**Product Change Notice (PCN)**

**Subject:** Change in test process for RH850/P1x, E1x, C1x, E2x series (alternative PKG Burn-in)

**Publication Date:** 7/25/2024

**Description of Change:**

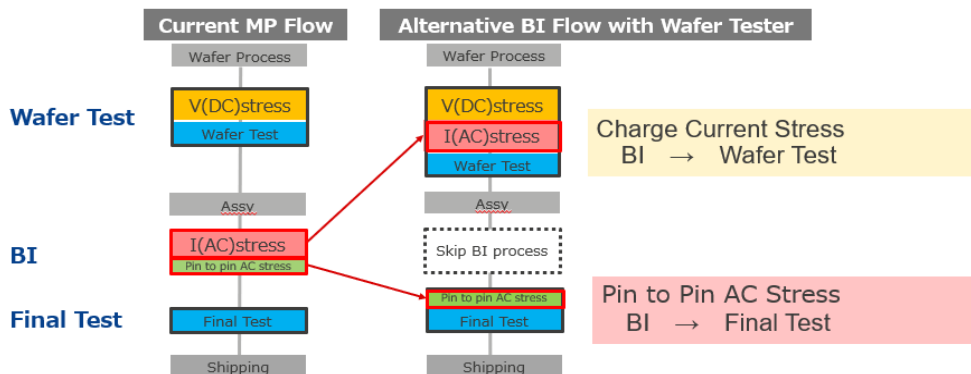
**TEST PROCESS CHANGE (ALTERNATIVE BURN-IN)**

This change replaces the stress test which checked out initial failures in Current BI Flow to Wafer Test and Final Test.
